MIL-N-22239C(AS)
Amendment-1
15 January 1970

NAVIGATIONAL SET, TACAN AN/ARN-52(V)

This amendment forms a part of Military Specification MIL-N-22239C(AS) dated 1 December 1967 and has been approved by the Naval Air Systems Command, Department of the Navy.

Figure 1B. Case for Receiver-Transmitter RT-(*)/ARN-52(V)

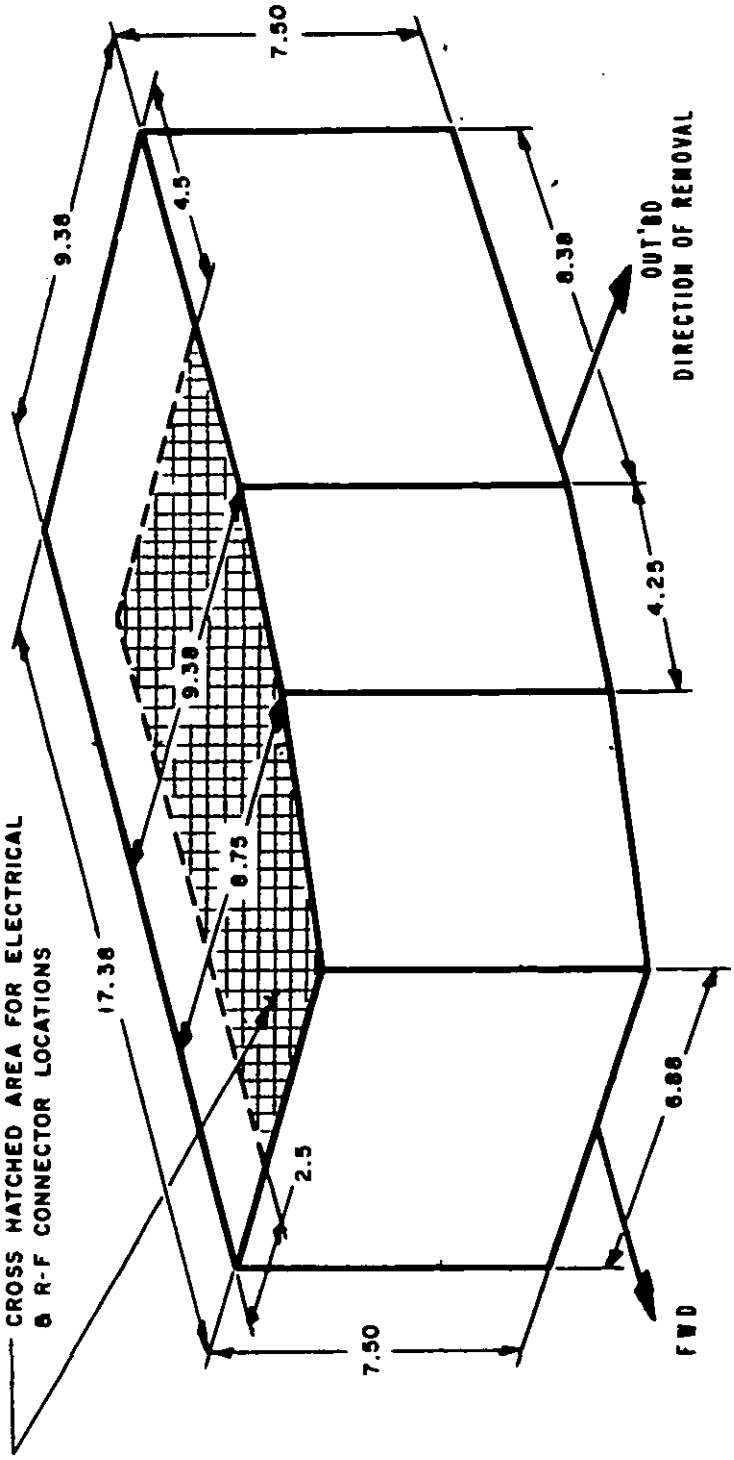
Page 17, paragraph 3.5.1.2: Delete and substitute

"3.5.1.2 Form Factor - The form factor of the RT-893/ARN-52(V), RT-384/ARN-52(V) and RT-(*)/ARN-52(V) receiver-transmitters shall comply with Figures 1, 1A and 1B respectively."

Page 27: Add

"3.5.8 Mounting MT-2091/ARN-65(V) - A vibration and shock-absorbing mounting MT-2091/ARN-65(V) shall be provided for the RT-(*)/ARN-52(V) receiver-transmitter with a form factor as shown on figure 1B. Its loaded height shall not exceed 1.50 inches. The allowable sway space shall be as shown on figure 5C.
